From: Doreen Gavin <DGAVIN@AHBL.com>
Sent: Monday, January 7, 2019 11:08 AM
To: Eatch Beck - Capital Projects <BeckE@ckschools.org>; Thiel Sydney - Capital Projects <SydneyT@ckschools.org>; Nick Rheaume <NRheaume@AHBL.com>
Cc: Johnny Hong <jhong@integrusarch.com>; Richard Wilson (rwilson@integrusarch.com) <rwilson@integrusarch.com>; Mike Hager <mhager@AHBL.com>; Craig Skipton <CSkipton@AHBL.com>
Subject: RE: Soule Drainage Pipe

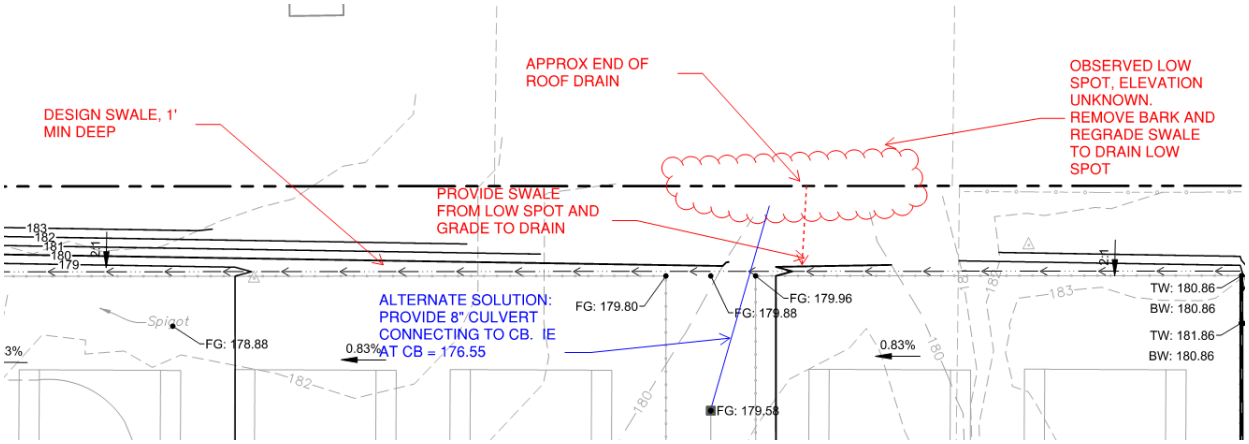
Mike and I field reviewed the Soule property to the north of the tennis courts. We observed a 4' drain pipe from the property outletting onto the school district property. It is most likely the roof drainage. This pipe was not identified in the design survey. The survey contours and spot elevations do not pick up the elevation at the low spot in the Soule property back yard near their fence. It is lower than 180.

The design intent shown on the drawings is to provide a swale along the north edge of the tennis courts. The V-ditch should be a minimum of 1 foot deep and slope to the west, eventually outletting into the ditch along Frontier. I see two possible solutions:

Option 1. Establish the ditch as shown below in red. Removing bark and regrading is necessary to provide the ditch 1 foot deep and maintain a slope of .83% to the west. The elevation of the low spot should be obtained as well as the outlet end of the roof drain pipe to confirm this depth of swale is adequate.

Option 2. Provide a 8" culvert from the low spot at the north property line and connect to the tennis court CB. Repair HMA paving.
